PREDETERMINATION SETTLEMENT AGREEMENT

CP# 02-18-71593
HUD# 07-18-8485-8

Carman consists of four buildings – Buildings 2, 3, 4, and 5 – located at 2314 East Porter Avenue. The ground-floor dwelling units and common use/public areas will all be required to meet the same accessibility requirements of the ICRA and FHA. All four buildings at Carman were issued Certificates of Occupancy signed by Corey Christiansen, Building Official for the City of Des Moines, Iowa, on June 12, 2017.

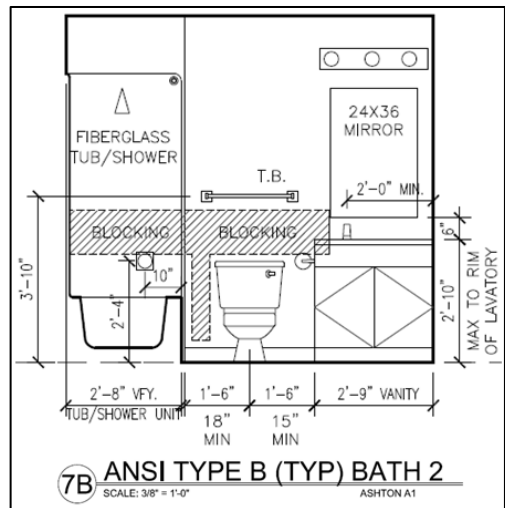
6) The plans submitted by Respondents included the following instructions and diagram for the installation of the towel bars in Ashton units:

The figure above indicates the towel bars were designed to be installed above the toilets at a height of 46" above the finished floor. The heights of the towel bars in both bathrooms in Unit 16 were measured at no less than 57 1/2", and were installed above toilets that have a depth of 27", which exceeds the 25"-maximum allowed depth for obstructions. Therefore, towel bars or hooks will need to be installed at a height of no more than 54" on a different wall that has no obstructions.

As designed and built, the towel bars in Unit 16 are too high, rendering them unusable by persons using wheelchairs.⁸

4) Respondents will install towel hooks at heights that do not exceed the 54”-maximum height allowed by ANSI 1986 – which is the maximum height allowed if there is sufficient clearance for a parallel approach by someone in a wheelchair – on a wall without obstructions in the bathroom of Unit 16 and of all other ground-floor units verified by Respondents to have towel bars exceeding the 54”-maximum height.

- 4) ICRC agrees with Respondents' proposal to install towel hooks at heights that do not exceed the 54"-maximum height allowed by ANSI 1986 – which is the maximum height allowed if there is sufficient clearance for a parallel approach by someone in a wheelchair – on a wall without obstructions in the bathroom of Unit 16 and of all other ground-floor units verified by Respondents to have towel bars exceeding the 54"-maximum height.
